CITY PLAN COMMISSION**THURSDAY, DECEMBER 5, 2024****FILE NUMBER:** S245-040**SENIOR PLANNER:** Sharmila Shrestha**LOCATION:** Hill Oak Drive between Parakeet Lane and West Wheatland Road**DATE FILED:** November 6, 2024**ZONING:** PD 598 (Tract 1A)**PD LINK:** <https://dallascityhall.com/departments/city-attorney/Articles/PDF/Article%20598.pdf>**CITY COUNCIL DISTRICT:** 8**SIZE OF REQUEST:** 1.074-acres**APPLICANT/OWNER:** JSDN Real Estate, LTD

REQUEST: An application to replat a 1.074-acre tract of land containing portion of Lots 7, 10, and 11 in City Block 7561 to create one lot on property located Hill Oak Drive between Parakeet Lane and West Wheatland Road.

PRELIMINARY PLAT

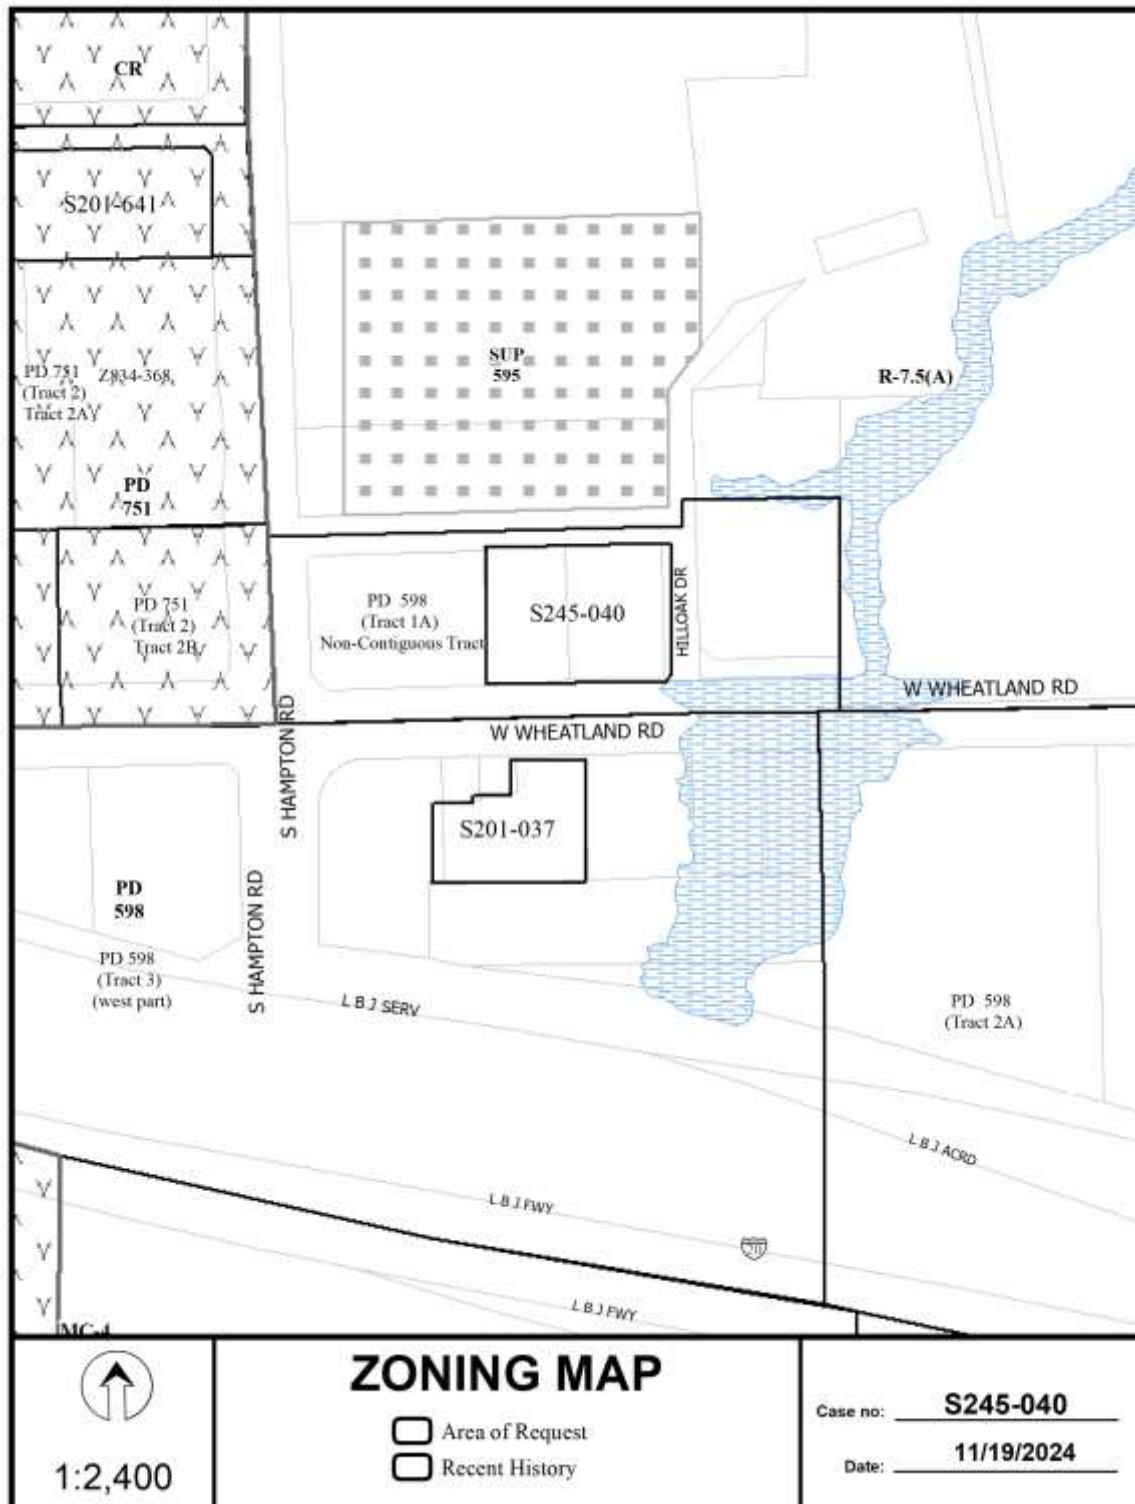
16. On the final plat, dedicate 28 feet of right-of-way (via fee simple or street easement) from the established centerline of Parakeet Lane. Sections 51A-8.602(c), 51A-8.604(c) and 51A-8.611(c).
17. On the final plat, dedicate 28 feet of right-of-way (via fee simple or street easement) from the established centerline of Hill Oak Drive. Sections 51A-8.602(c), 51A-8.604(c) and 51A-8.611(c).
18. On the final plat, dedicate a minimum 5-foot by 5-foot corner clip (via fee simple or street easement) at the intersection Parakeet and Hill Oak Drive. Section 51A 8.602(d)(1)
19. Prior to final plat, a larger corner clip may be requested during engineering plan and traffic review to accommodate an adequate turning radius, or to maintain

20. Prior to final plat, submit a completed final plat checklist and all supporting documents.
21. On the final plat, show abstract line location.

22. Additional design information is required for assessment. Site plan must be submitted showing proposed development, building finished floor elevation, development, existing mains – including downstream manhole, and proposed water and wastewater service locations. Submit water/wastewater engineering plans to 320 E. Jefferson Blvd., Room 200, Attention: Water and Wastewater Engineering.

23. Prior to final plat, comply with City's Street lighting standards including illumination standards, material, installation, and activation per Street Design Manual.
24. On the final plat, change "West Wheatland Road" to "Wheatland Road (FKA Wheatland-Duncanville Road)". Section 51A-8.403(a)(1)(A)(xii).
25. On the final plat, change "Parakeet Lane" to "Parakeet Lane (FKA Main Street)". Section 51A-8.403(a)(1)(A)(xii).
26. On the final plat, identify the property as Lot 7A in City Block 7561.
